**ADDENDUM NO. 1**

**PROJECT NAME:** East Stadium Repairs & Waterproofing, 2012  
**UNL PROJECT NUMBER:** C049P138

**DATE OF ISSUANCE:** April 4, 2012  
**DATE OF BID OPENING:** Tuesday, April 17, 2012

PLANS OF SECTIONS A AND O

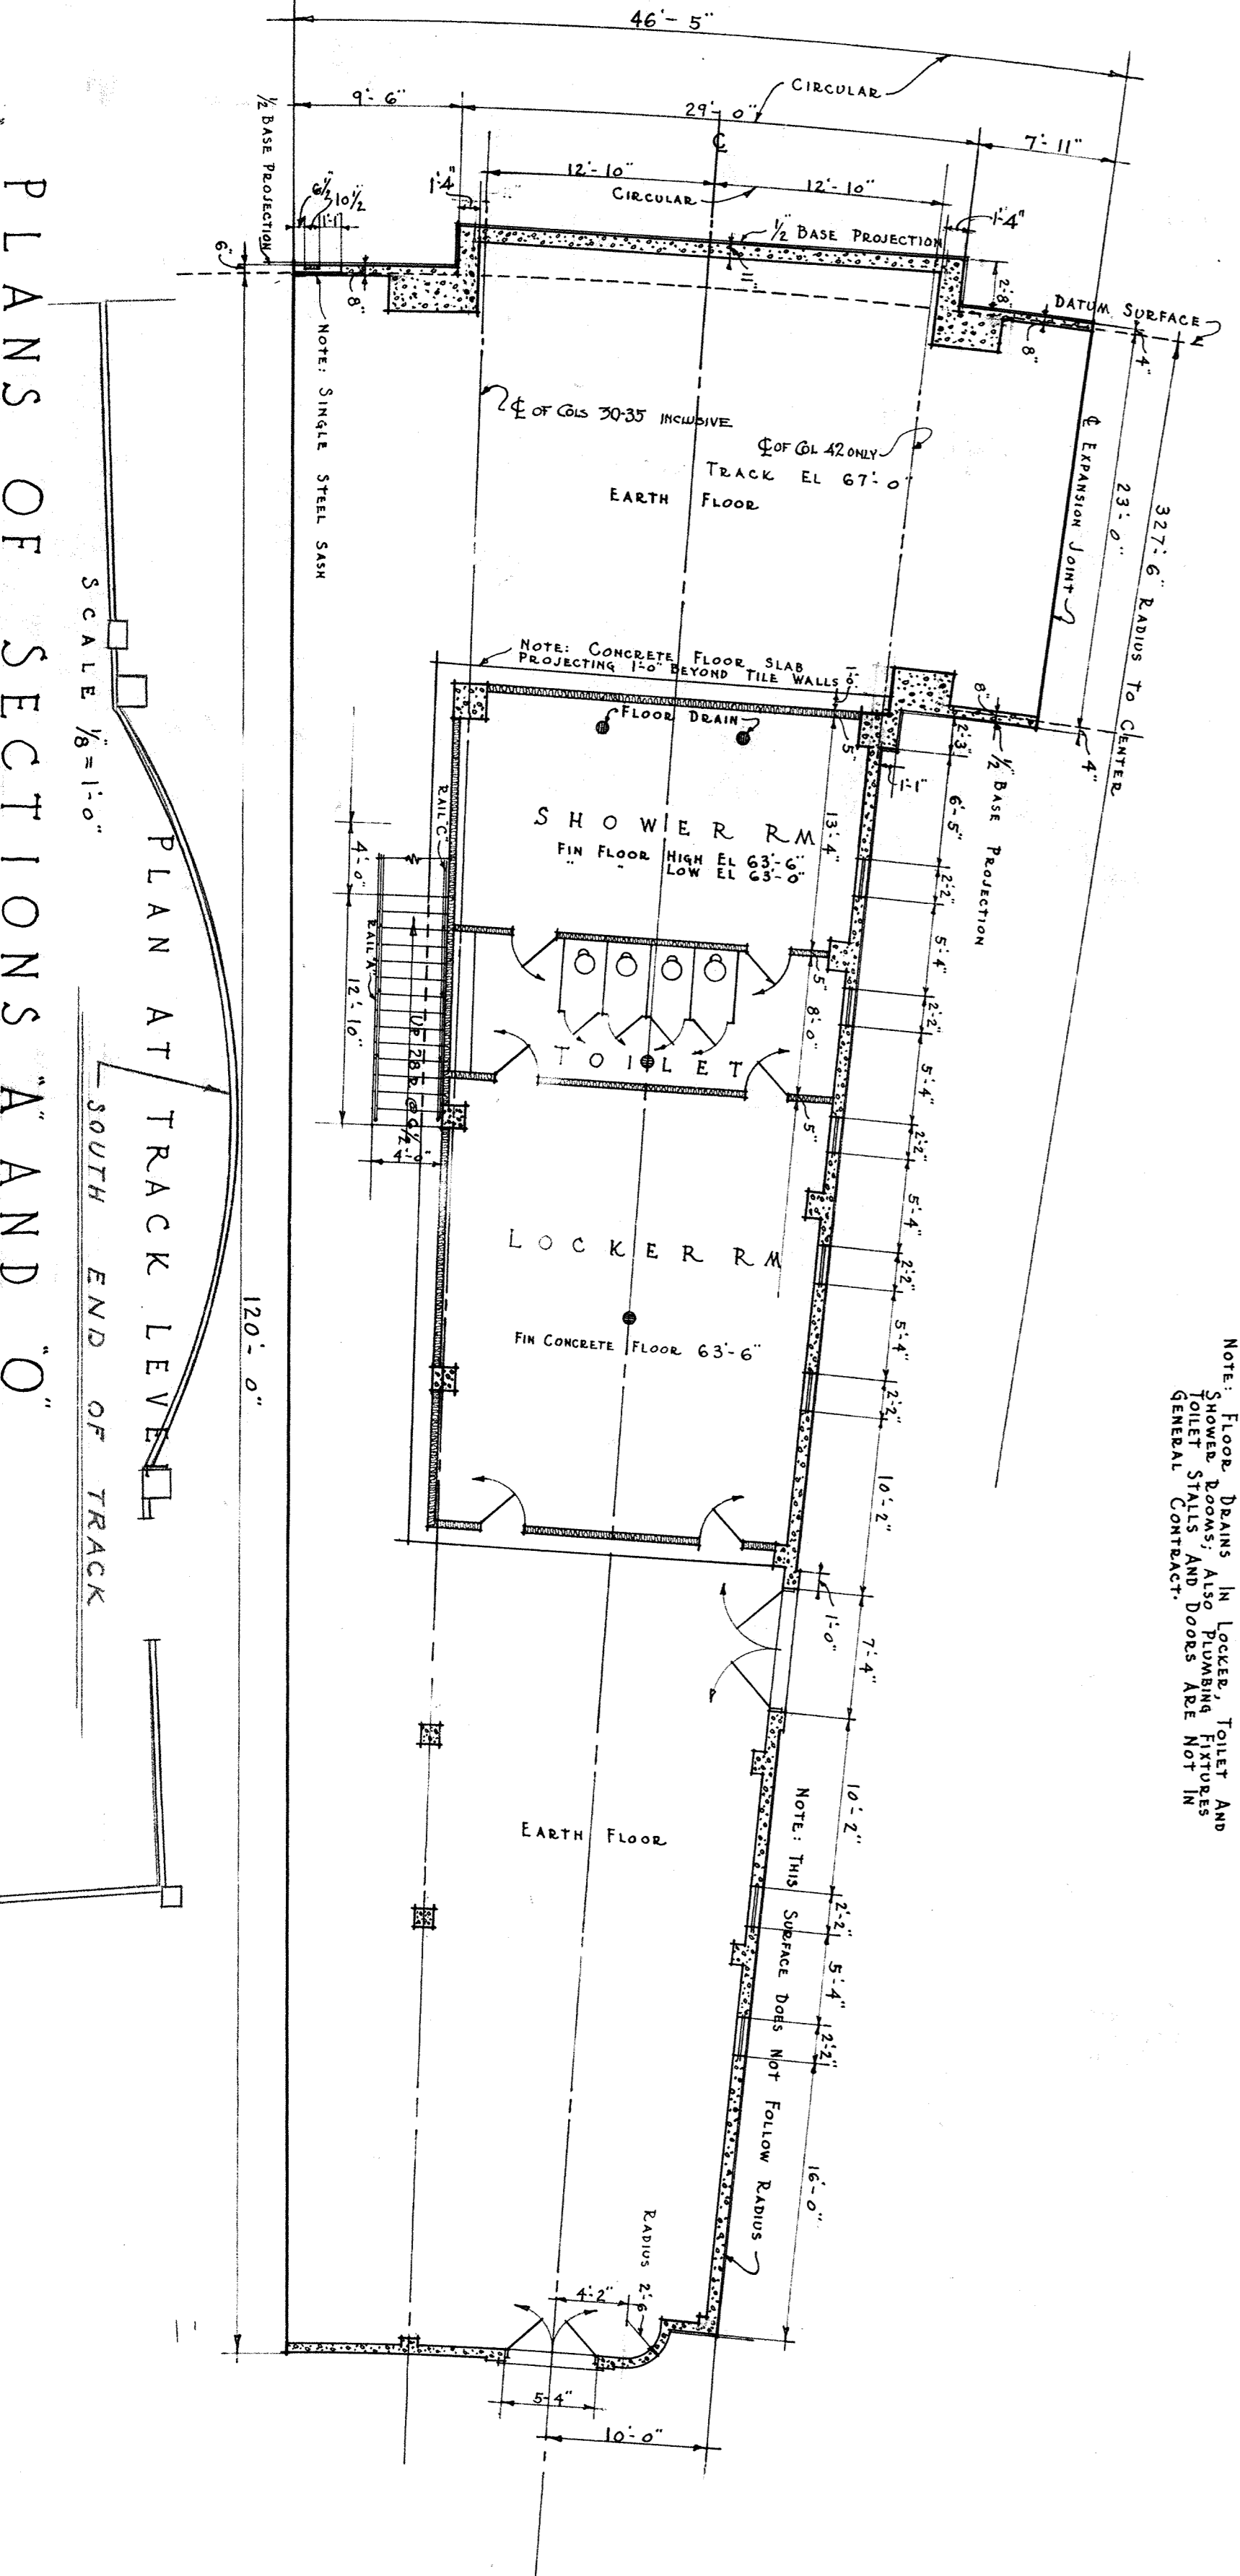
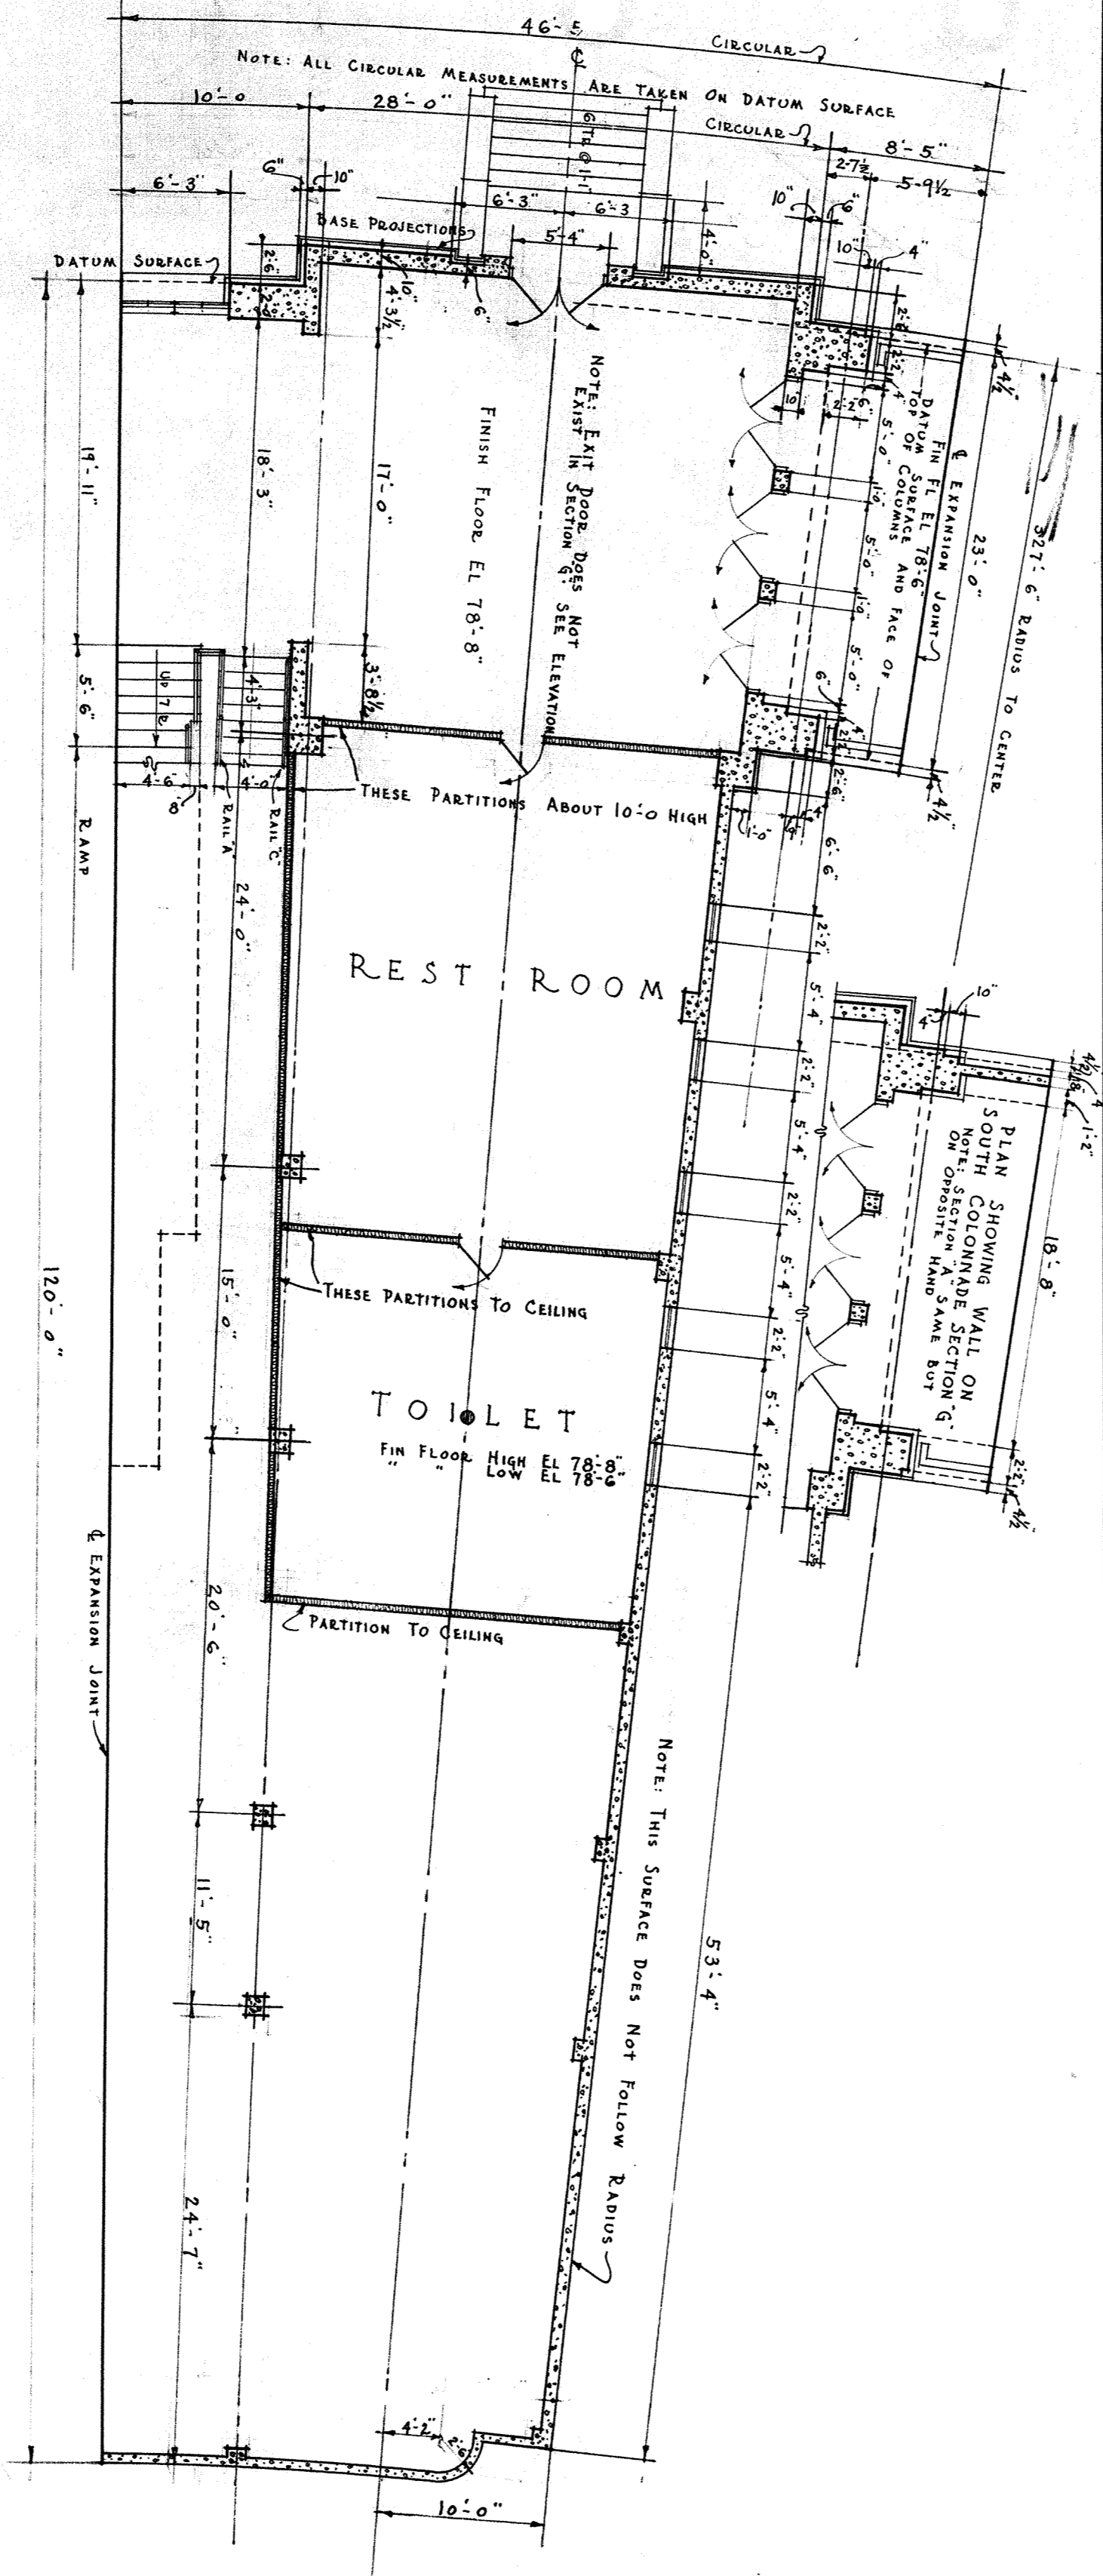
**Item # 7 See the attached, partial, existing building plan:**

- a. See attached plan for general reference. The accuracy and dimensions shown have not been verified by the Owner nor the consultant. The bidder/Contractor is to field verify existing conditions.
